Westinghouse Electric Company LLC
Hematite Decommissioning Project
3300 State Road P
Festus, MO 63028
USA

Subject: Hematite Decommissioning Project - Revision to the Westinghouse Hematite Decommissioning Plan Chapter 9 (License No. SNM-00033, Docket No. 070-00036)

**Hematite Decommissioning Plan:
Chapter 9 Revision, Westinghouse Letter HEM-14-43**

**Hematite Decommissioning Plan:
Change Evaluation Form - Change Number CEF-14-DO-08-004-Chapter 9
Westinghouse Electric Company LLC, Hematite Decommissioning Project
Docket No. 070-00036**

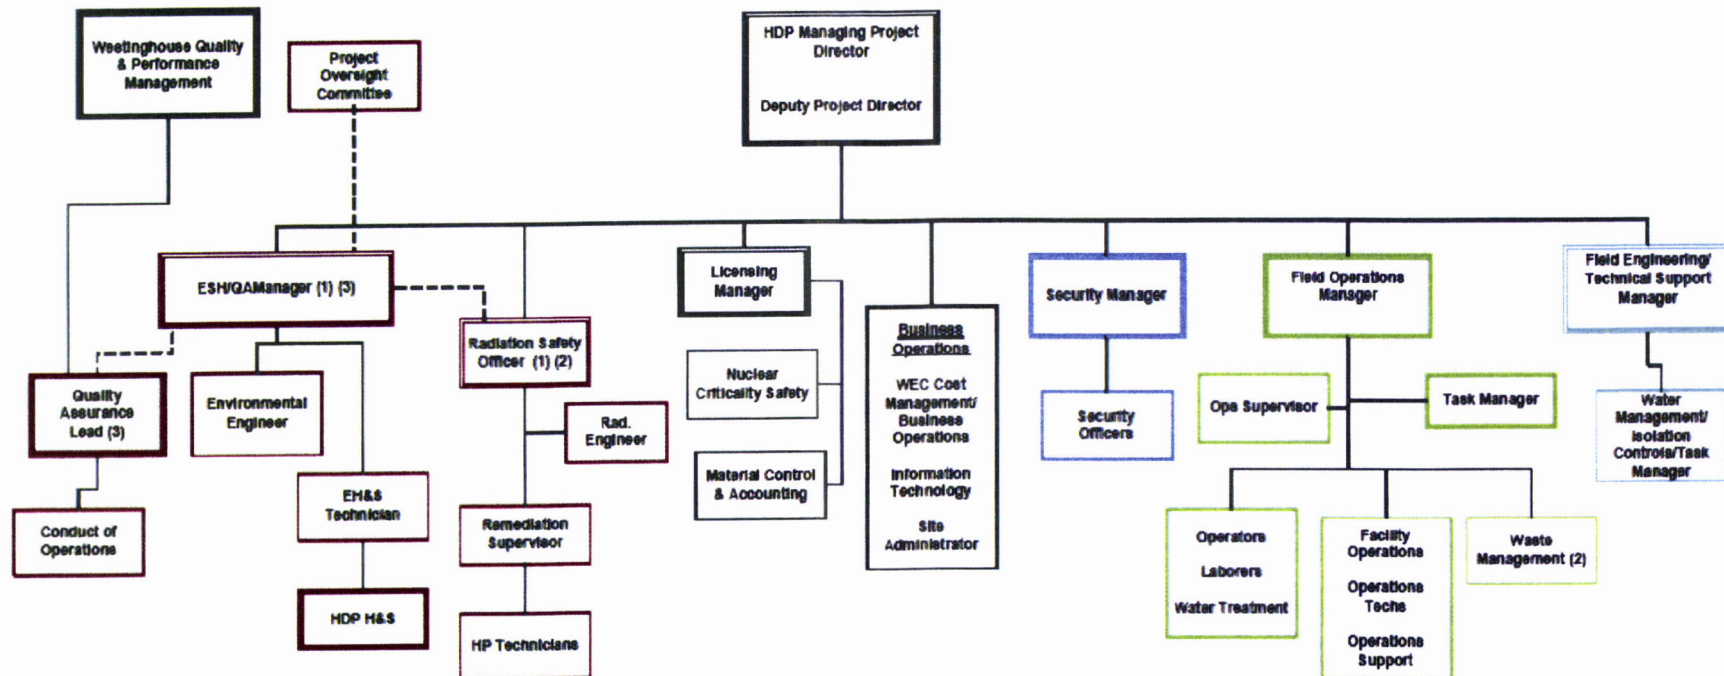
There are no changes in regards to the functional area responsibilities and authorities. The proposed organization has been established to ensure the requirement of HDP-PO-QA-001, Project Quality Plan (PQP) section 7.6 is met in that to maintain independence the Quality Assurance Lead reports to the Westinghouse Electric Company Nuclear Services Business Unit Quality & Performance Management. The ESH/QA Manager reports to the Project Director.

(1). RSO reports to the Project Director for radiation protection functional area responsibilities. RSO reports to ESH/QA Manager for schedule, budget and coordination of activities.

(2). Waste Management reports to the Field Operations Manager for schedule, budget and coordination of activities. Waste Management programmatic responsibilities and authority resides with the RSO.

(3). Quality Lead reports to Westinghouse Quality & Performance Management. Quality Lead reports to ESH/QA Manager for schedule, budget and coordination of activities.
